**VOLUME 2B
Comments and Responses
L-310 through L-372 and
SL-1 through SL-134**

**FINAL
ENVIRONMENTAL IMPACT STATEMENT
ENVIRONMENTAL IMPACT REPORT**

**FOR THE
CALIFORNIA-OREGON
TRANSMISSION PROJECT**

**AND THE
LOS BANOS-GATES
TRANSMISSION PROJECT**

FIGURE 1

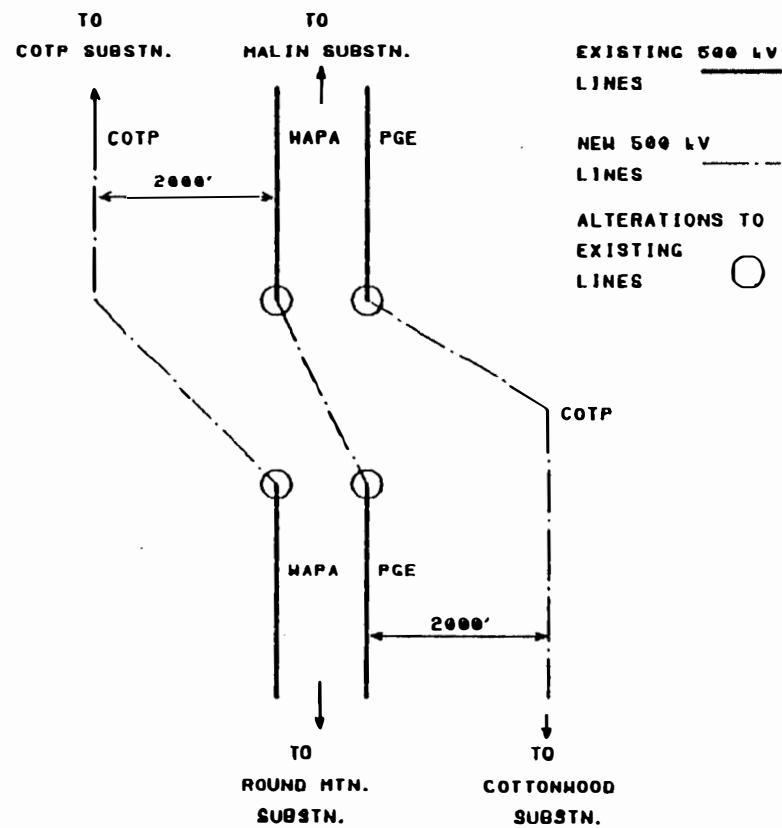
- 1) Simply trading lines as shown in Figure 1 at the north end of the project just south of Malin, thus reducing the crossings of the existing line intertie to one in scrubland northeast of Anderson. This configuration could have significant reliability benefits providing the Round Mountain substation with two sources of supply and taking one circuit from Malin straight to Cottonwood. This configuration must receive a reliability analysis similar to
